**ADDENDUM #1**

TITLE: 2019-CM-073 GREENWICH BAY COASTAL OLD  
FORGE ROAD & POST RD. EXTENSION

**Greenwich Bay Coastal - Old Forge Rd & Post Rd Extension**

NOTICE TO PROSPECTIVE BIDDERS

**DRAINAGE & UTILITY**  
**PLAN NO. 1**

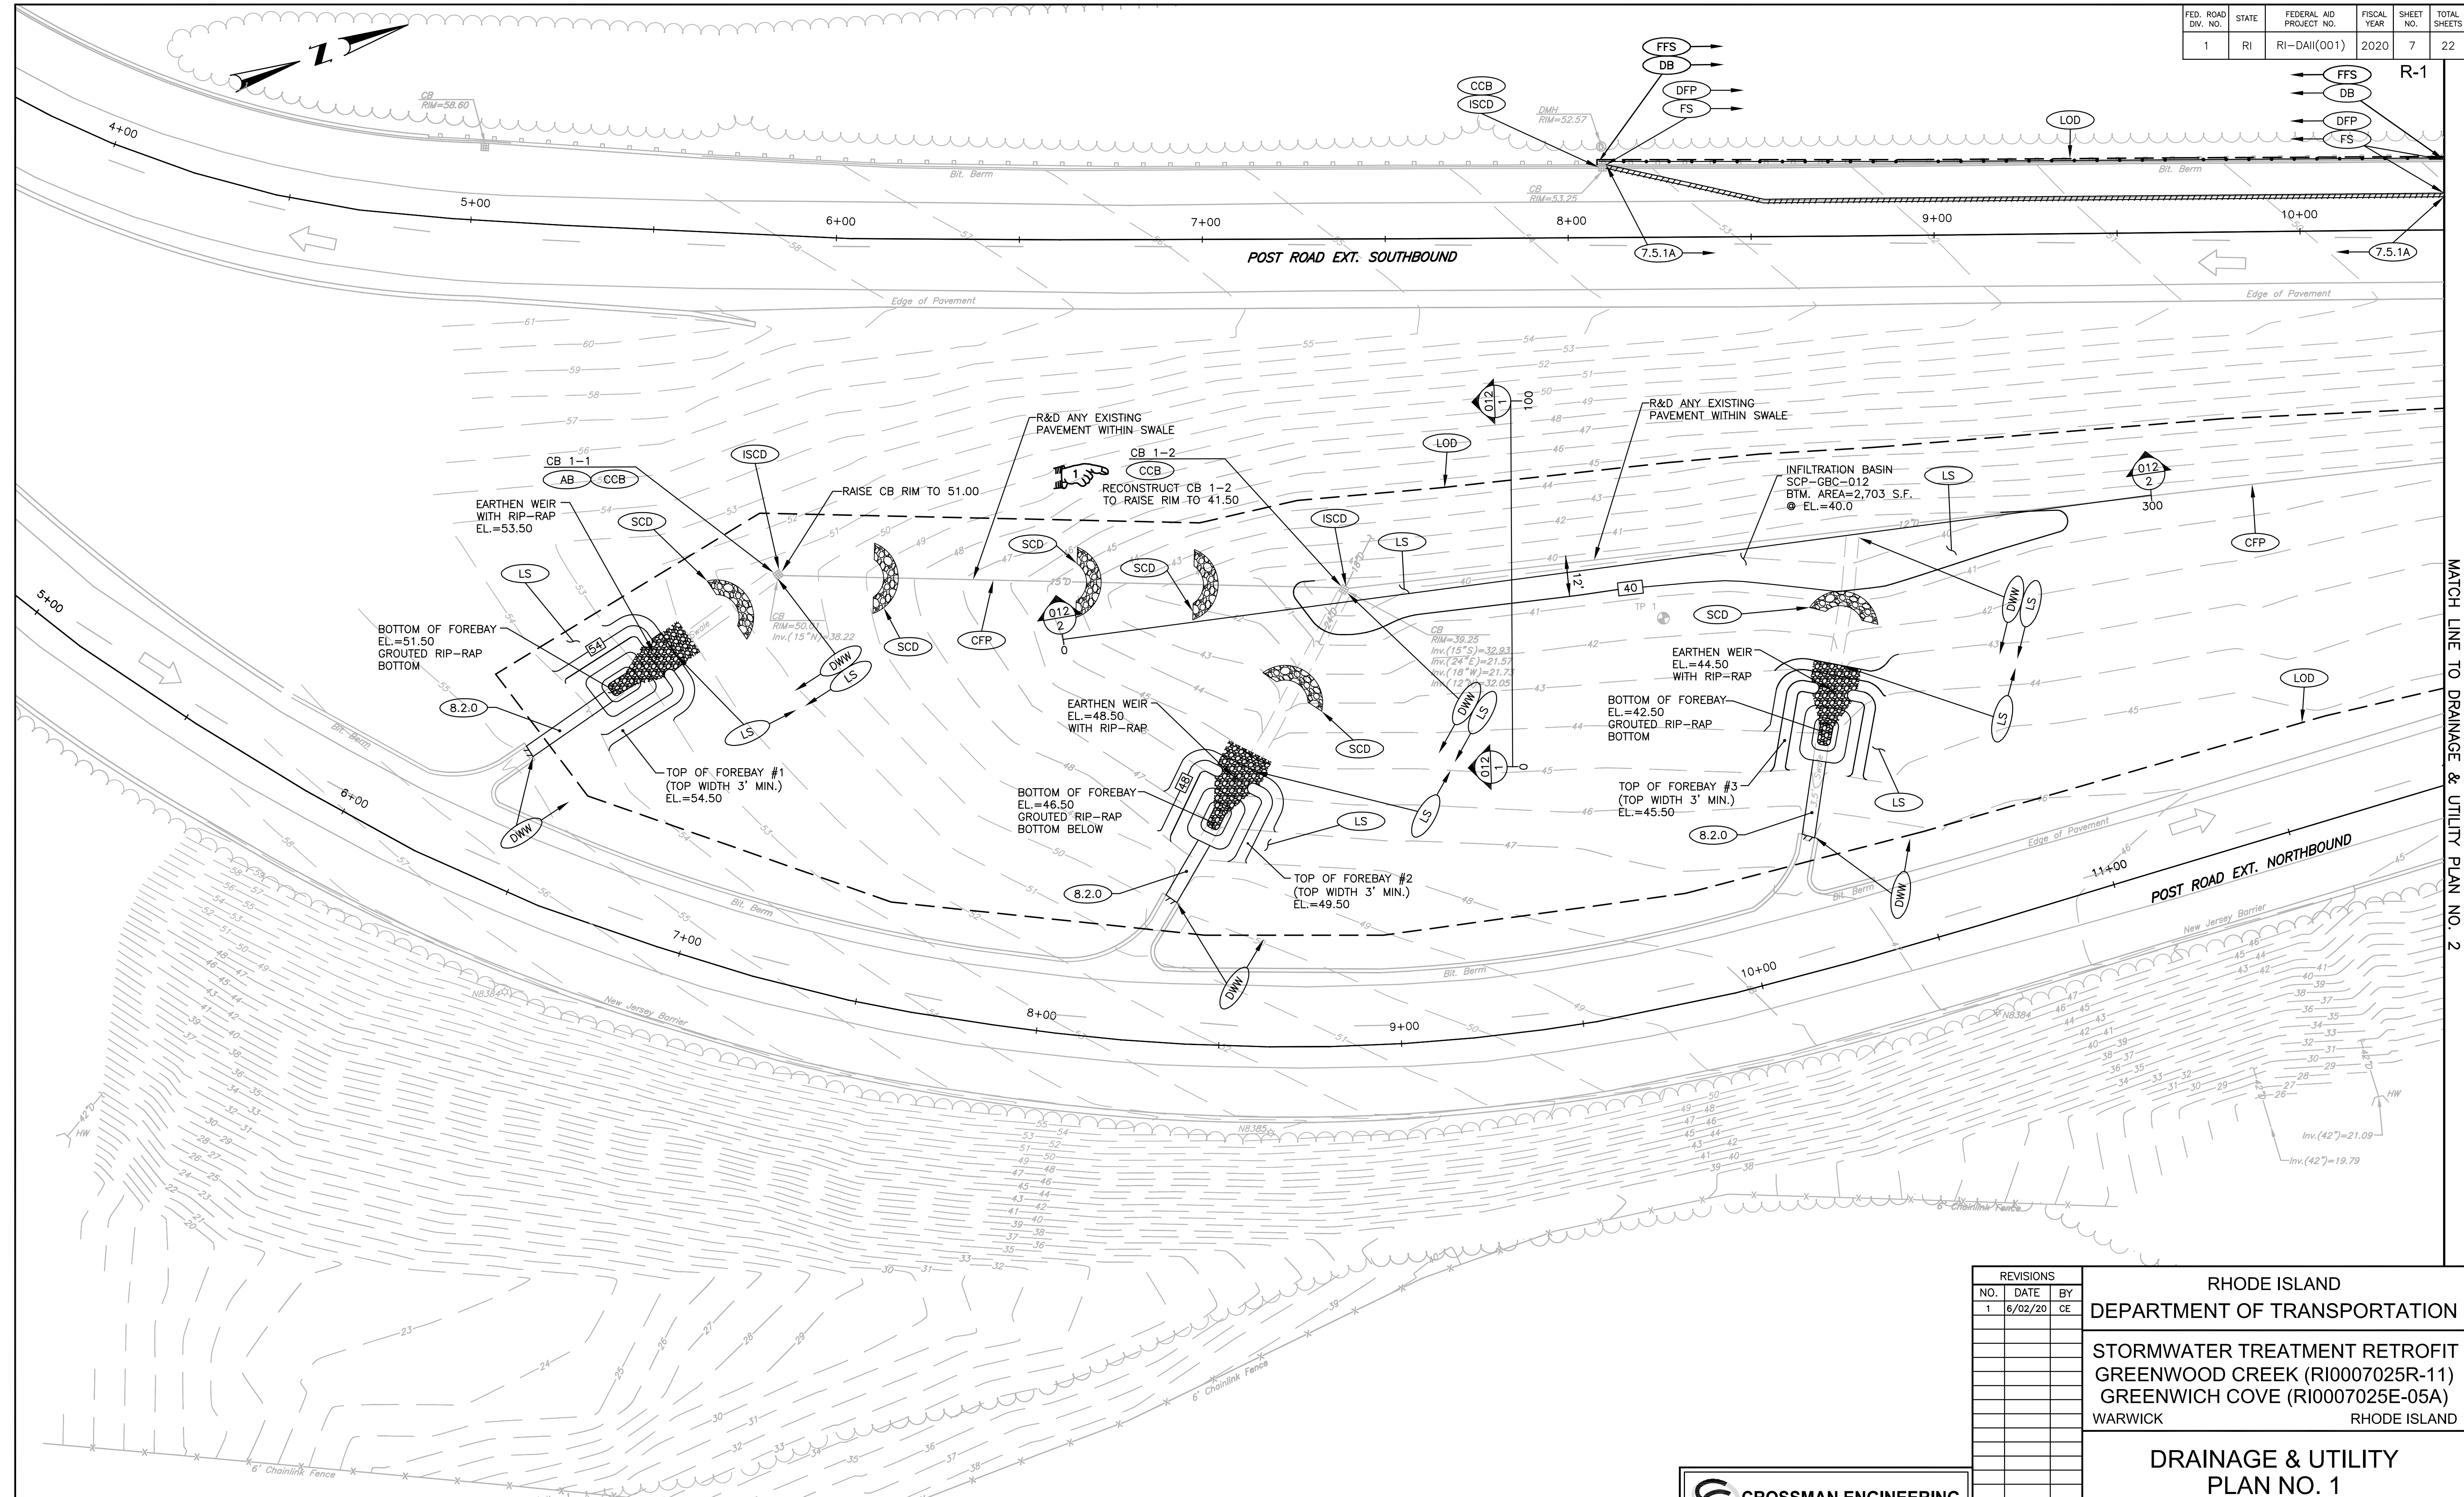
1. Sheet No. 7 – Drainage & Utility Plan No. 1

Delete Sheet No. 7 in its entirety and insert revised Sheet No. 7 (R-1) attached to this Addendum No. 1. The callout for proposed work at CB 1-2 has been revised.

**TYPICAL EARTHEN WEIR DETAIL**

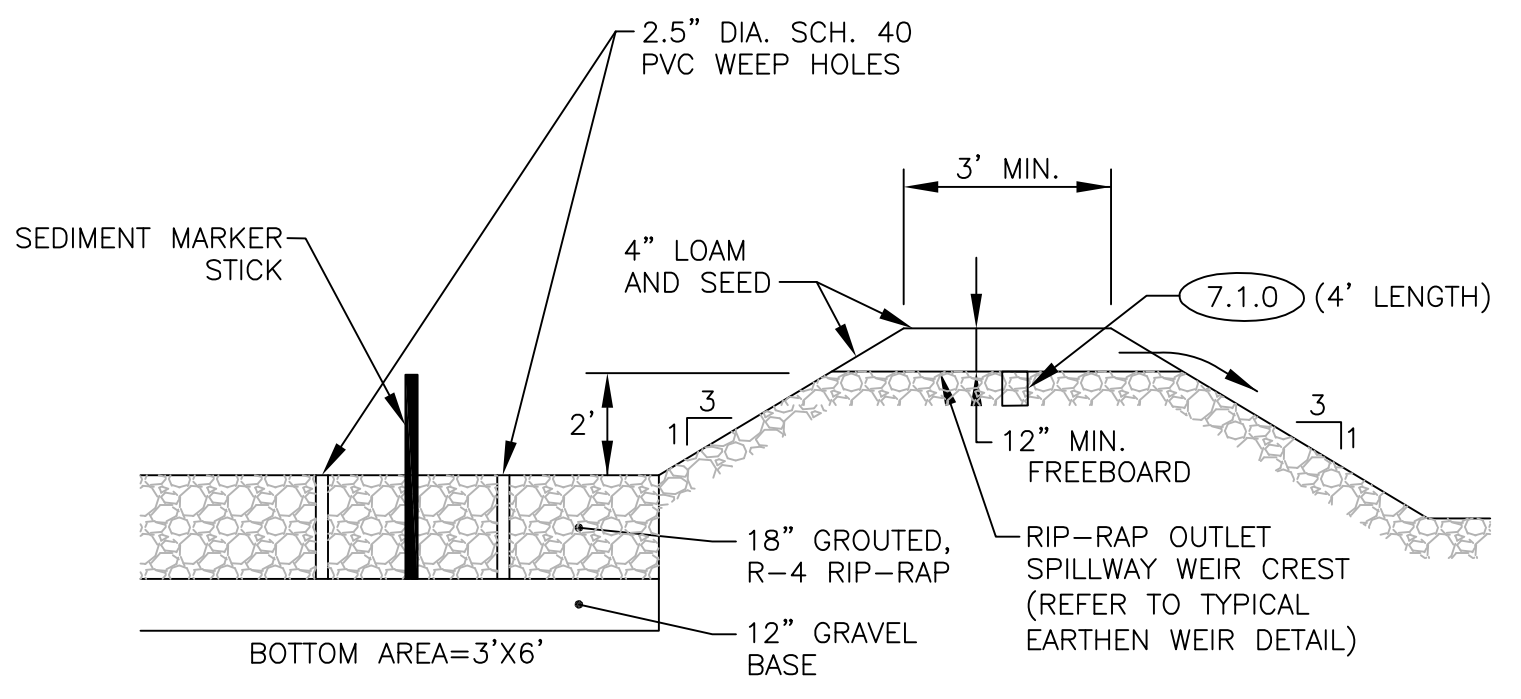
- Infiltration System Construction Note No.2 has been revised.
- The Typical Earthen Weir Detail has been revised.
- The Typical Sediment Forebay Detail has been revised.

**TYPICAL EARTHEN BERM DETAIL**  
NOT TO SCALE

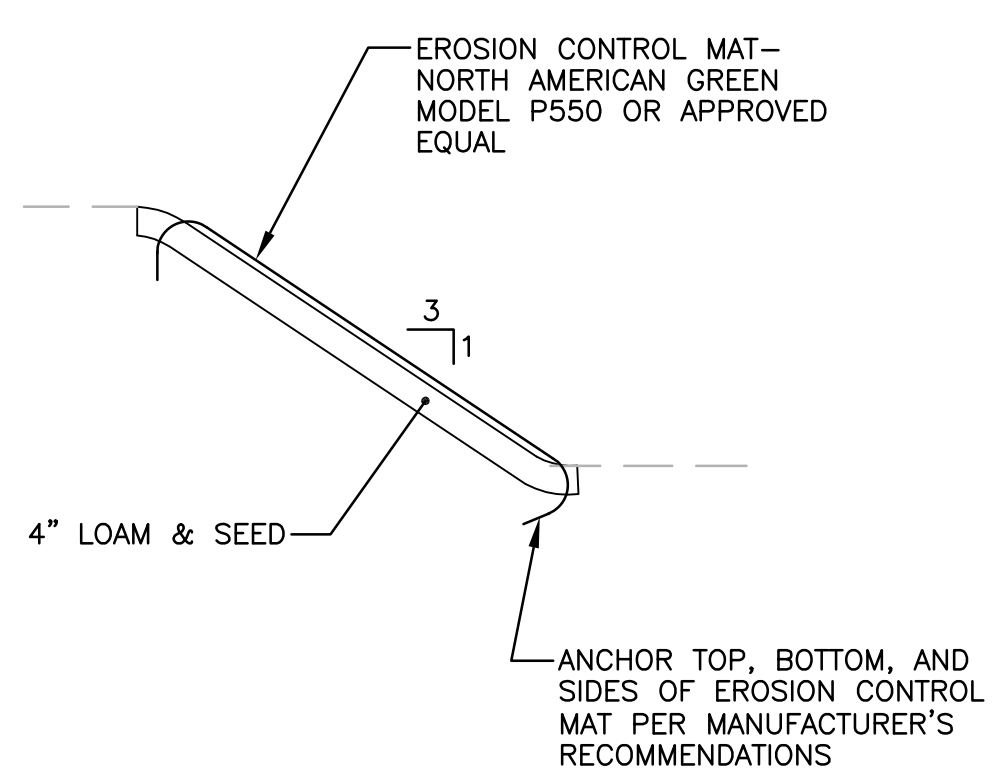
Delete Sheet No. 22 in its entirety and insert revised Sheet No. 22 (R-1) attached to this Addendum No. 1. The Typical Earthen Berm Detail has been revised.

- NOTES:**
- BERM HEIGHT DETERMINED BY BERM TOP ELEVATION AS LABELED ON THE DRAINAGE & UTILITY PLANS.
  - BERM LENGTH TO EXTEND ACROSS SWALE WIDTH, FROM FRONT SLOPE TO BACK SLOPE, AT POINTS WHERE BERM TOP ELEVATION MEETS EXISTING SLOPE.
